#36/2-96C Ron LaDue/Brode LLC
Lot 48, Salisbury Road
Linden Historic District

PROPOSAL: New construction of 2 houses; Remove asbestos siding; Tree removal; Install temporary sign

ALTERNATIVE A

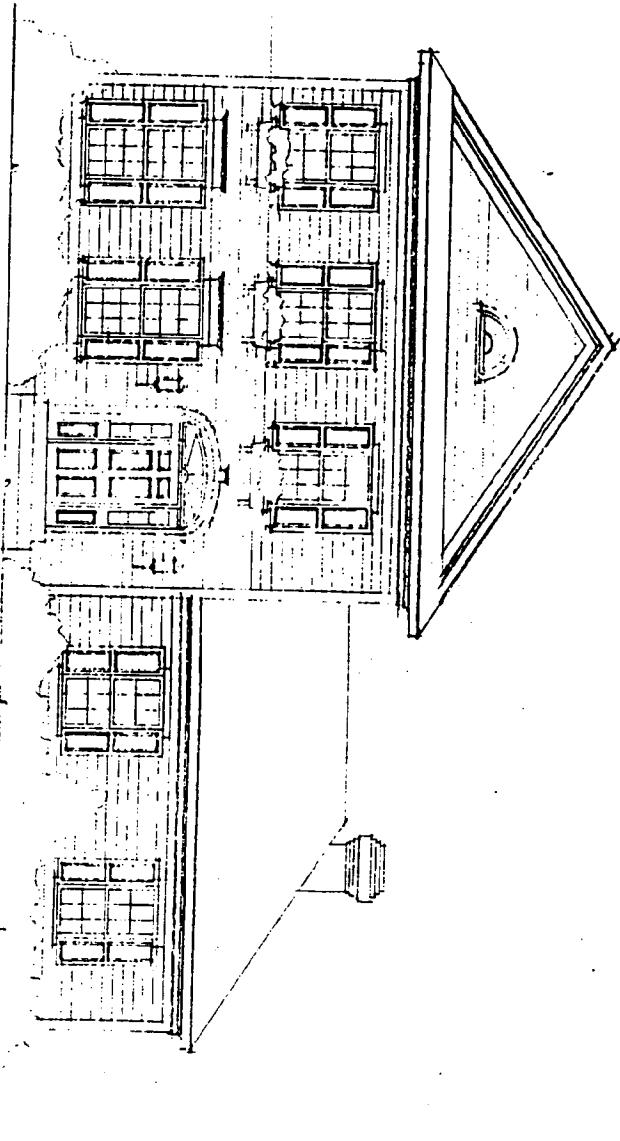
In summary, staff feels that the house proposed for Lot 48 is possible if the concept of an attached garage were eliminated. The house for Lot 47 should utilize Alternative A as an approach. Staff feels that due to the size of the lots and the flora to be retained, the proposal should be revised to delete garages.
